**SITE AND ARCHITECTURAL REVIEW COMMITTEE  
TUESDAY, DECEMBER 13, 2016  
6:30 p.m.**

**To:** Site and Architectural Review Committee **Date:** December 13, 2016  
**From:** Daniel Fama, Senior Planner *DF*  
**Via:** Paul Kermoyan, Community Development Director *PK*  
**Subject:** Planned Development Permit / Tree Removal Permit  
**File No.:** PLN2016-47/280 ~ 96 E. Rincon Ave.

**To:** Site and Architectural Review Committee **Date:** December 13, 2016  
**From:** Cindy McCormick, Senior Planner *CM*  
**Via:** Paul Kermoyan, Community Development Director *PK*  
**Subject:** Site and Architectural Review Permit and Tree Removal Permit  
**File No.:** PLN2016-343 ~ 910 Emory

**TREE INVENTORY TABLE**

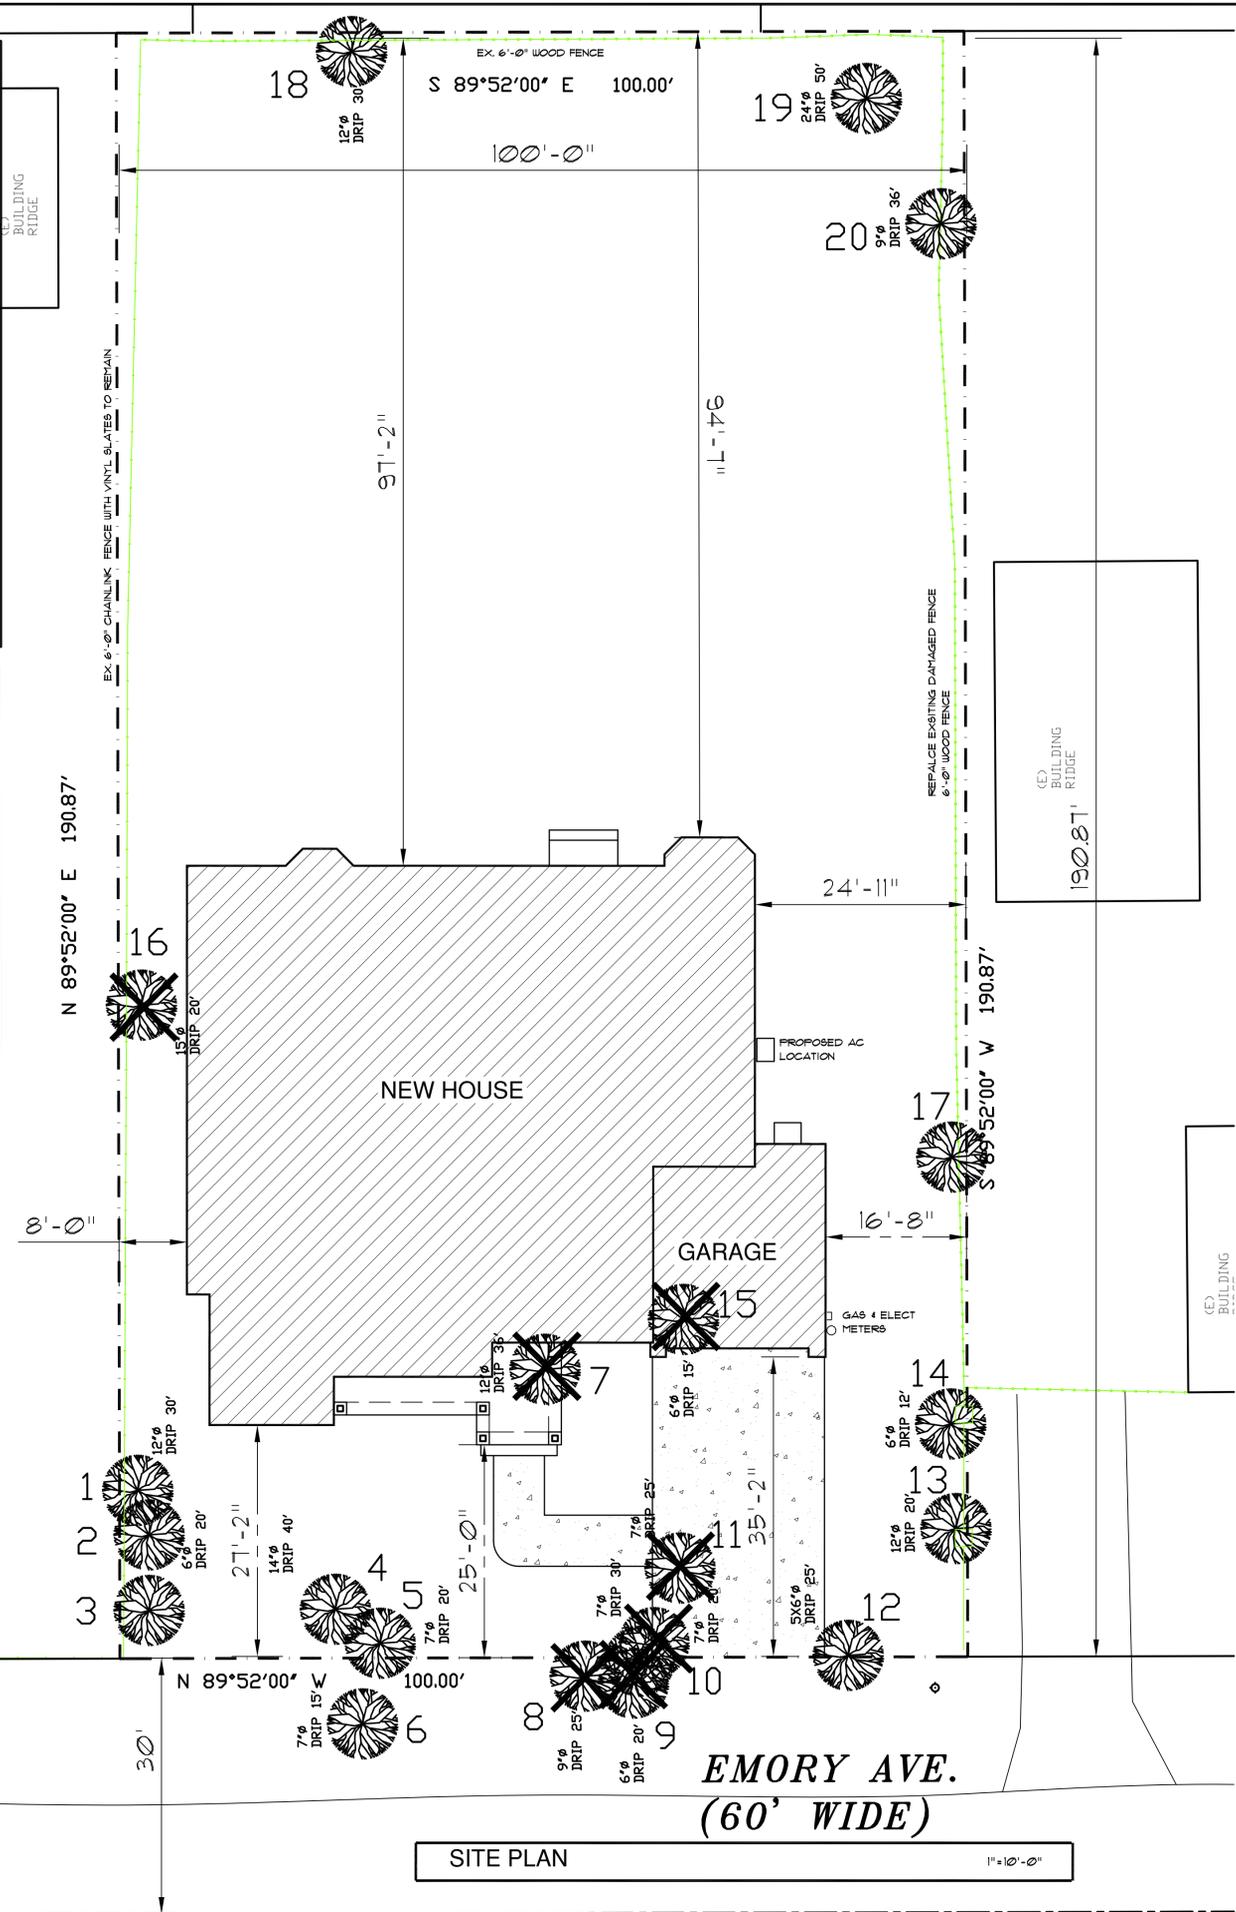
The on-site trees proposed for removal include #7 - a 16-inch pepper tree (considered invasive) and #16 - a 16-inch red cedar tree which is in “poor” condition and “dying from the top down” according to the Arborist Report (Attachment 3). The applicant is also proposing to remove three (3) holly oak trees: #15 (6-inches); #11 (10-inches); and #10 (12-inch double trunked). According to the Arborist survey, all of the holly oak trees proposed for removal are in “fair” condition.

Staff requested the applicant consider locating the home further back on the site in order to retain tree #15, the 6-inch holly oak tree which is located where the garage is proposed. Tree #15 is considered to be in “fair” condition but could be preserved through proper care and maintenance. However, the applicant has indicated that the owner would like to have the ability to build an accessory dwelling unit in the rear of the lot. The owner would like to retain the proposed location of the home to allow for more open space in the rear yard for both the main dwelling unit and the future accessory dwelling unit. The owner would also like to maintain the predominant front setback on the street which is similar to what is currently proposed (~30-feet).

Thirteen (13) trees are proposed to remain. However, only four (4) of these trees are reported to be in “good” condition according to the Arborist survey. The existing trees to remain meet the STANP requirement of one tree per 2,000 square feet of net lot area; however the applicant will also be required to plant new trees to replace the trees being removed. The Site and Architectural Review Committee (SARC) should consider whether the applicant should be required to preserve any additional trees on the property, including but not limited to tree #15.

LANDSCAPE PLAN

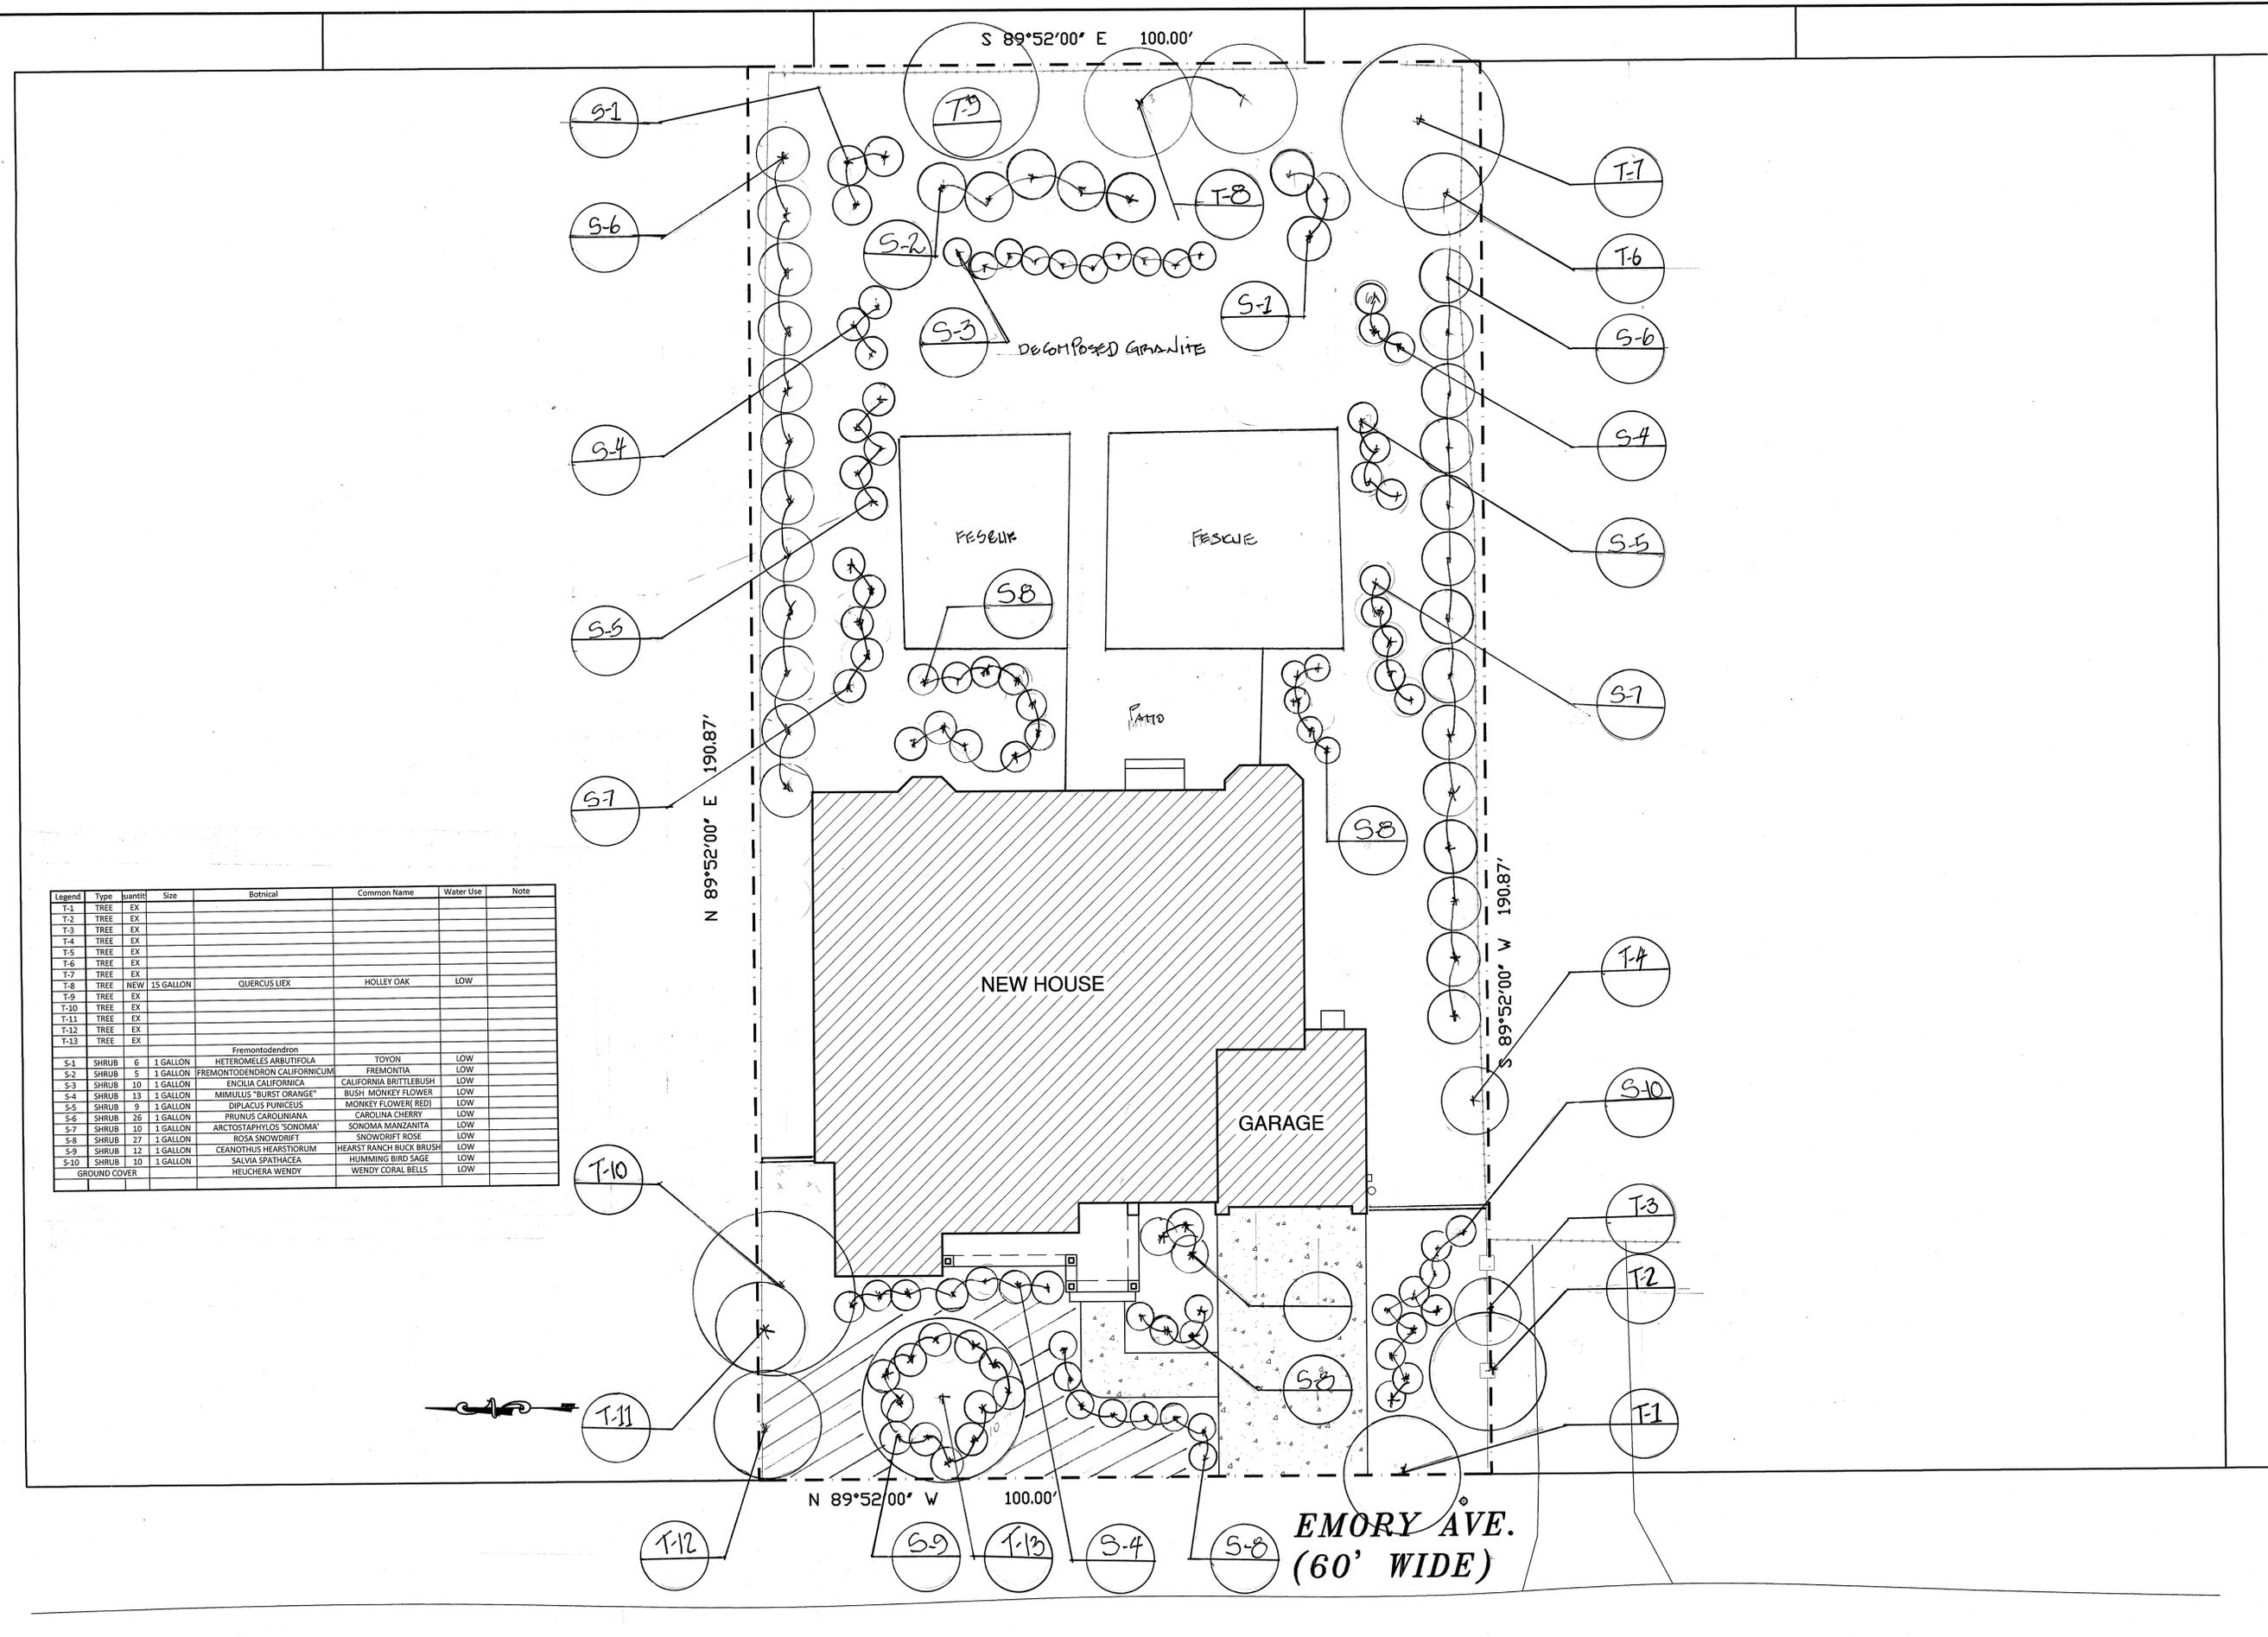
Site Layout and Landscaping: The single-story residence would be located on a large lot with larger than required front, side, and rear yard setbacks. The proposed landscaping includes hedges along the side property lines, and flowering shrubs, rose bushes, and perennial plants in the front yard (reference sheet L1 of Attachment 2).

- **Hardscape:** Change the driveway and pathways of the front area to be permeable materials such as permeable pavers. This is consistent with the need to reduce runoff and maintain our aquifers, which as you know are critical to reduce the current rate of land which is sinking. This is also a design consistent with the rural characteristics of the San Tomas Area Neighborhood Plan and the characteristics of Emory, as street which falls in the classification of a street without improvements such as sidewalks.
- **Landscape:** Find something other than Holly Oaks which become invasive for the trees in the back. STACC board has suggested Olive trees, or Standard Citrus both of which are evergreen. Other options can be recommended by the developers landscape architect.
